# WLTP Validation 2 Lot1

## Preliminary Evaluation on LabProcICE Issues ACEA Informal Document

Version DTP 11

# Evaluation of test cell temperature during WLTC

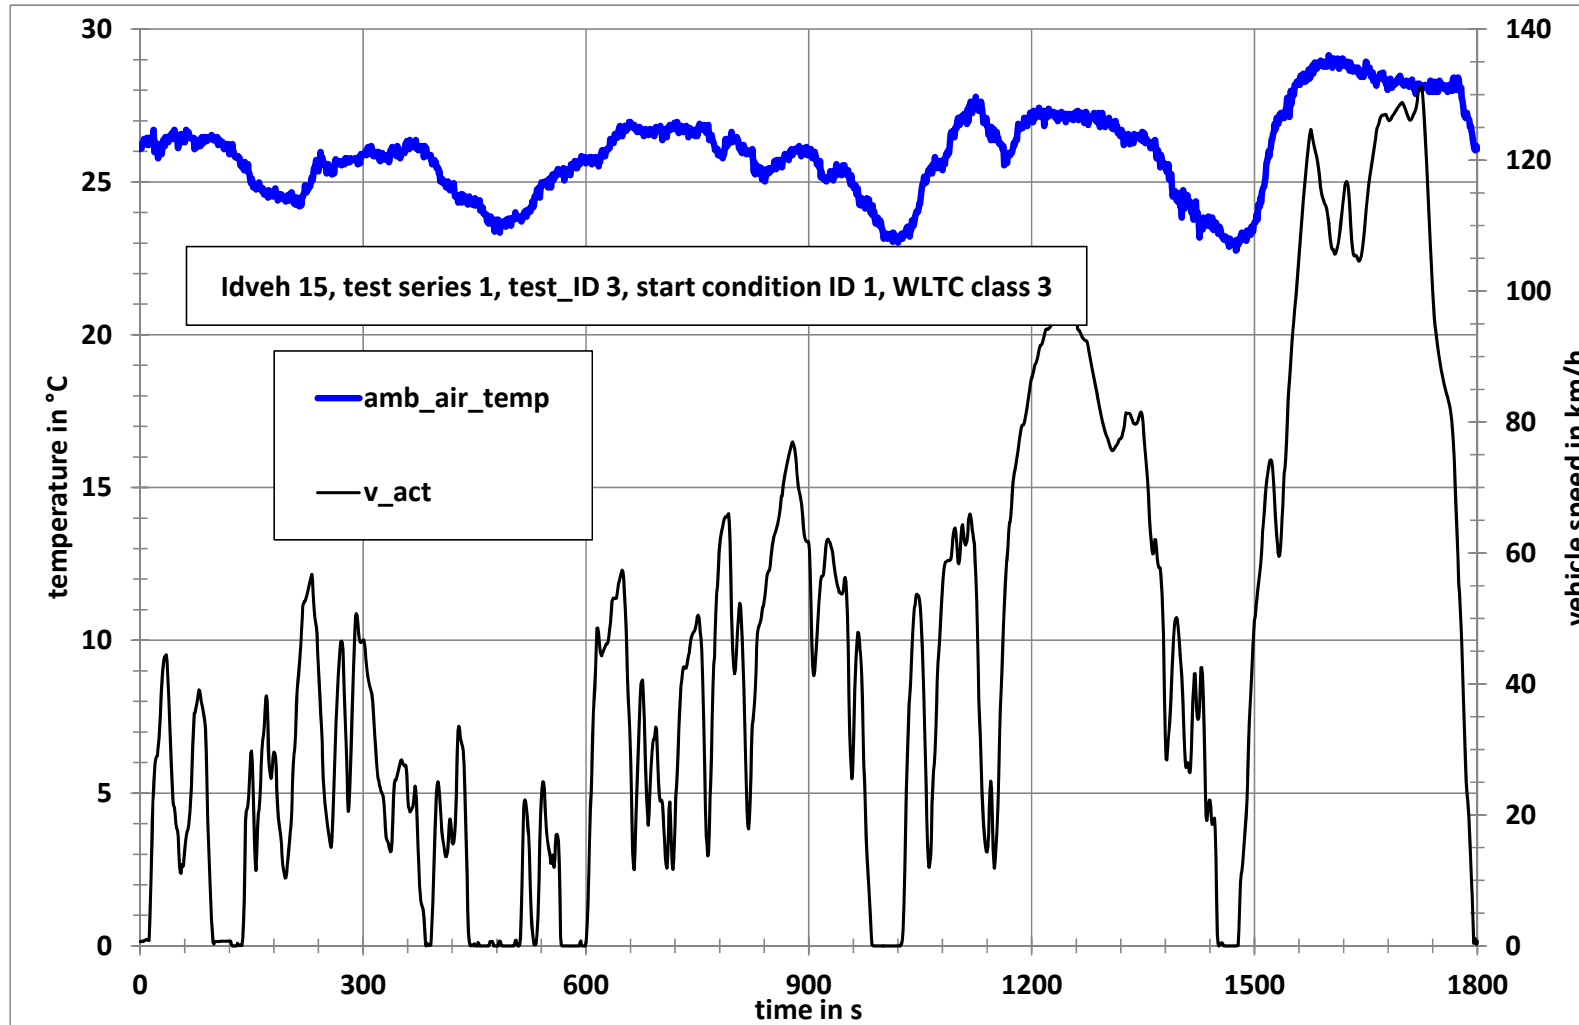
The tolerance of  $\pm 5$  K was not exceeded during VP2 testing, however the tighter tolerance of  $\pm 2$  K in some labs could not be kept with heavier vehicles. At the end of the driving cycle the heat input by the vehicle exceeded the ability of the air conditioning systems.

Stay with the setpoint of 298 K for the test cell temperature, but allow a  $\pm 5$ K tolerance after start of the engine for technical reasons (similar to US provisions)

# Evaluation of Humidity in the Test Cell during the Test

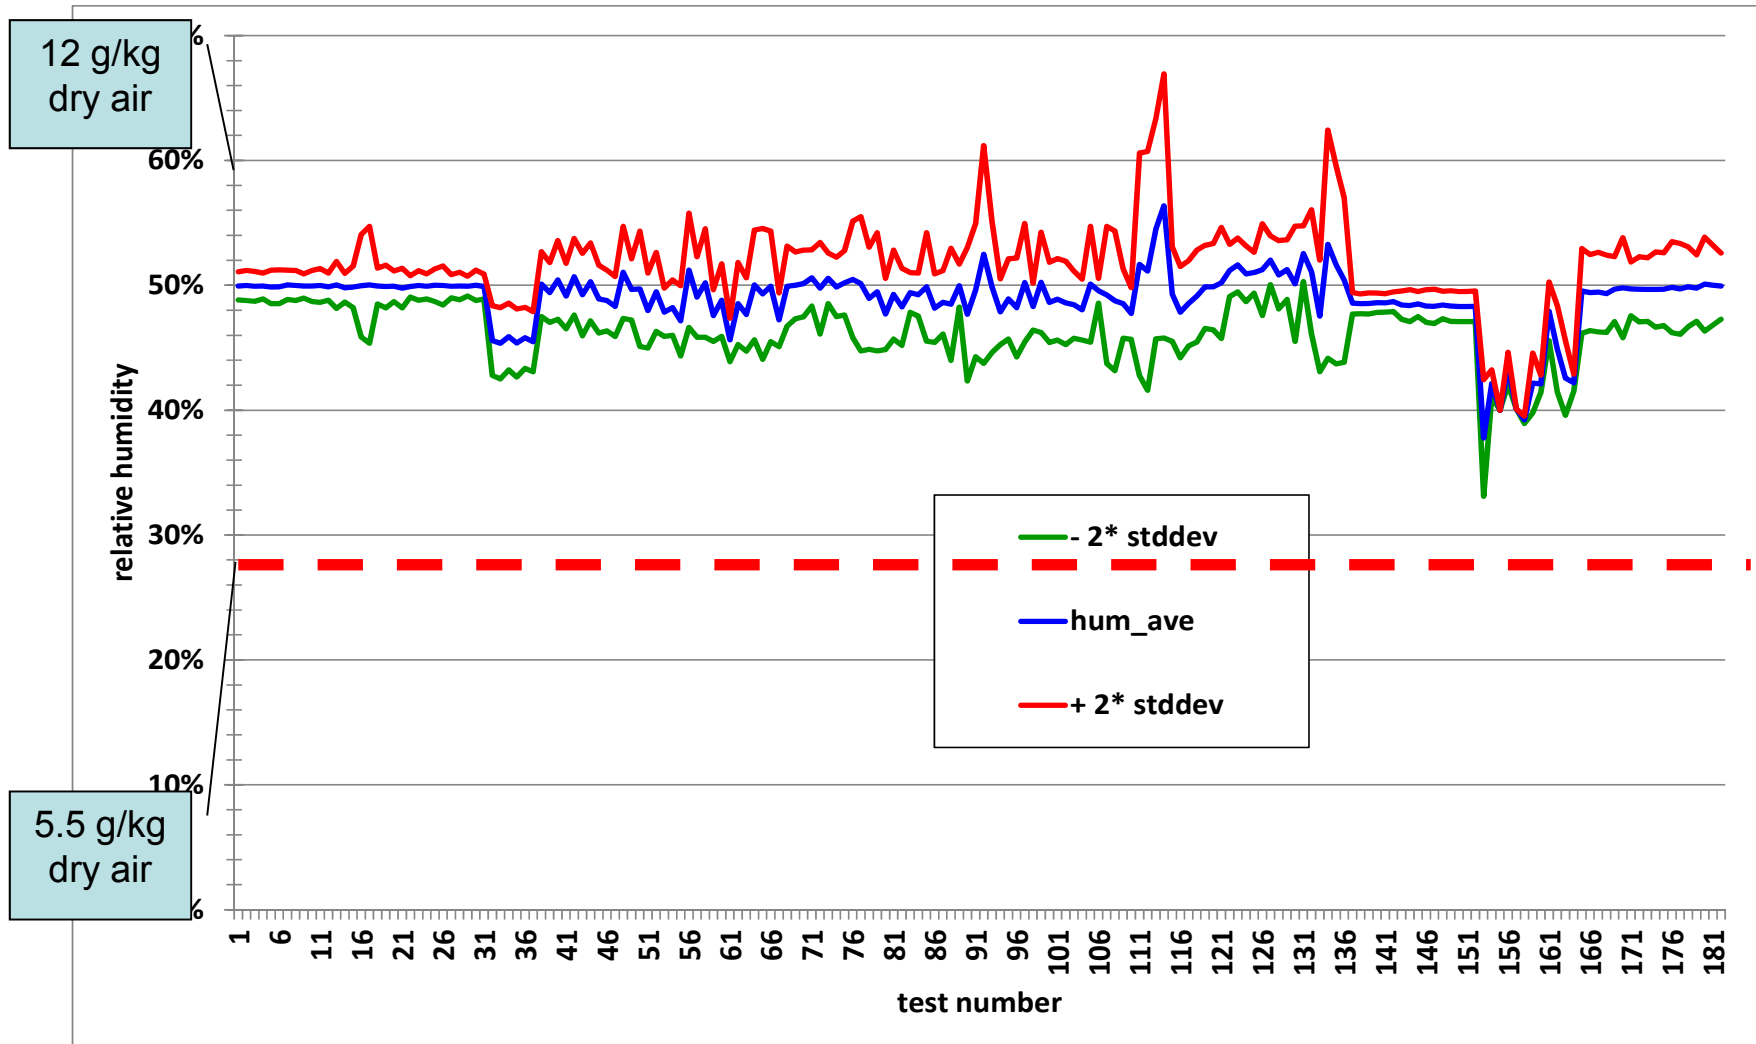
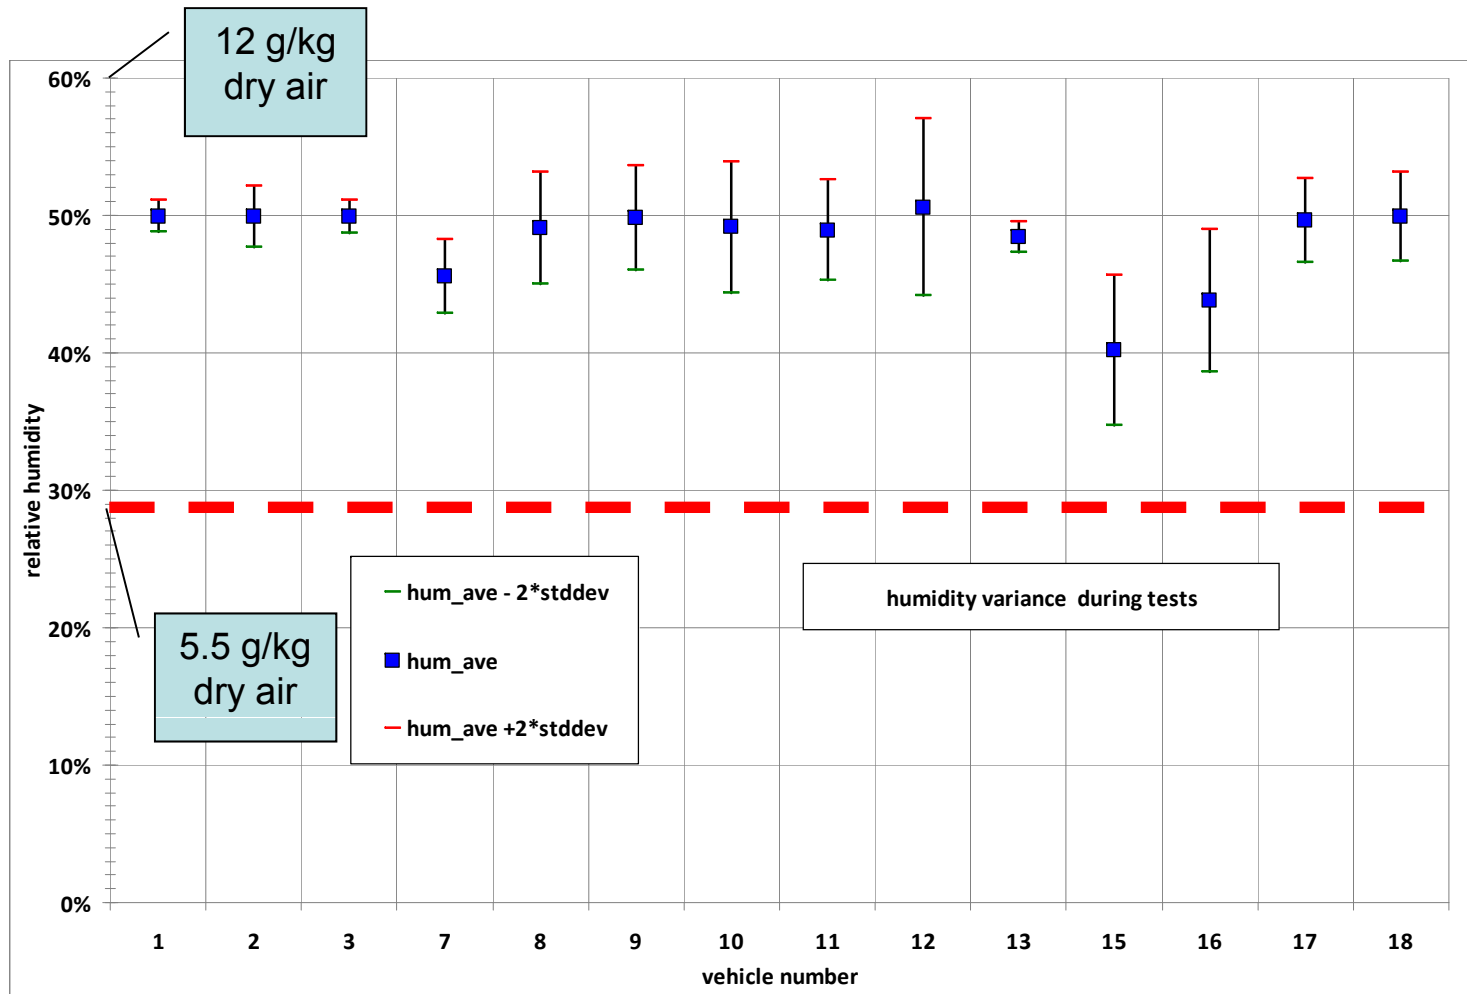
Vehicle tests in different labs shows variation of humidity within the tolerance

Stay with actual tolerance in gtr
